RE: SUBMISSION TO SSD-48028209, Residential development with infill affordable housing
Address: 16-24 Lord Street & 21-27 Roseville Avenue, Roseville

ATTACHMENT 1

Ku-ring-gai Council's objection to SSD- 78996460, 16-24 Lord Street & 21-27 Roseville Avenue, Roseville

Figure 2: extract SSDA-402 3D Massing (areas shown red are at or below the maximum building height)

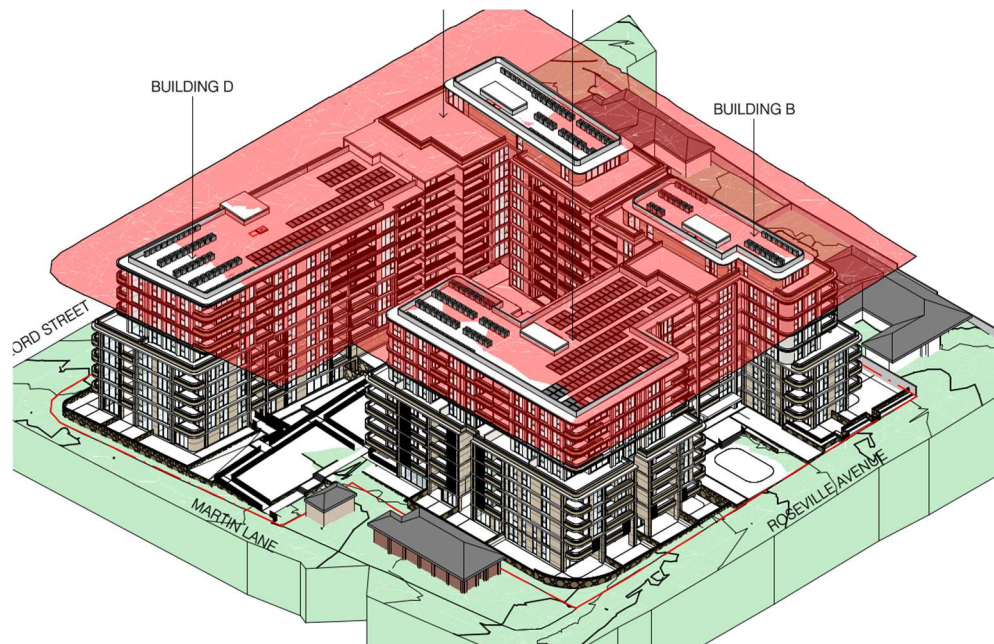
- The justification states that the additional building height is set back from the building edges of the building and is generally centrally located. It further specifies that the architectural design features such as recessing, landscape setting assist with the scale of the built form. **From figures 2-4** below it is evident that the proposed building height breaches are not centrally located and exist along the edges of the building. The building height breaches occur within the street frontages, adjoining lower density transition areas including the Heritage Item. It is also noted that the proposal does not comply with deep soil and does not provide sufficient space for canopy tree planting. The proposed building height along with the deficient landscaping exacerbates the massing of the built form and highlights the built forms incompatibility with the HCA, landscape setting and low density character of the area.

- It is agreed that the site has a sloping topography of approximately 6.5m across the Lord Street frontage, 2.6m fall across the Roseville Avenue frontage and up to 2.45m from NW-SE. In the absence of plans and diagrams which include sufficient level details it is difficult to fully understand the site topography and the relationship with building height. Whilst site constraints are environmental planning grounds, it has not been demonstrated that this constraint causes the breach of the building height development standard. It has not been demonstrated through analysis that a scheme compliant with the building height development standard is incapable of being achieved on the site. The proposal fails to adequately consider the interface with adjoining low density development in which a heightened degree of sensitivity is required. The proposed bulk and scale of the built form when viewed from all boundaries of the site is excessive and a more sensitive design could be adopted.

Sufficient environmental planning grounds must be advanced by the applicant to justify the proposed contravention. Greater consideration of the unique circumstances of the site is needed.

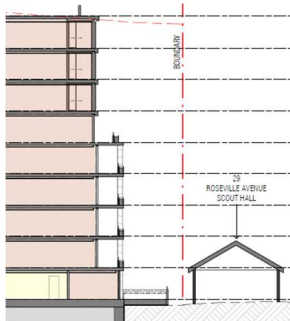
The proposed 9 storey building does not respect the established pattern of built elements in the streetscape as it is larger and taller than all the buildings in this part of the street and surrounding area. The proposed building has a sheer base of 5 storeys in height with a small setback of 4 storeys above.

There are insufficient setbacks between the built form and insufficient setbacks on the upper levels to provide a transition between the adjacent buildings of different scales.

Section F

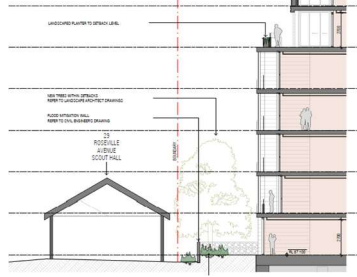
Setback from Scout Hall Buildings
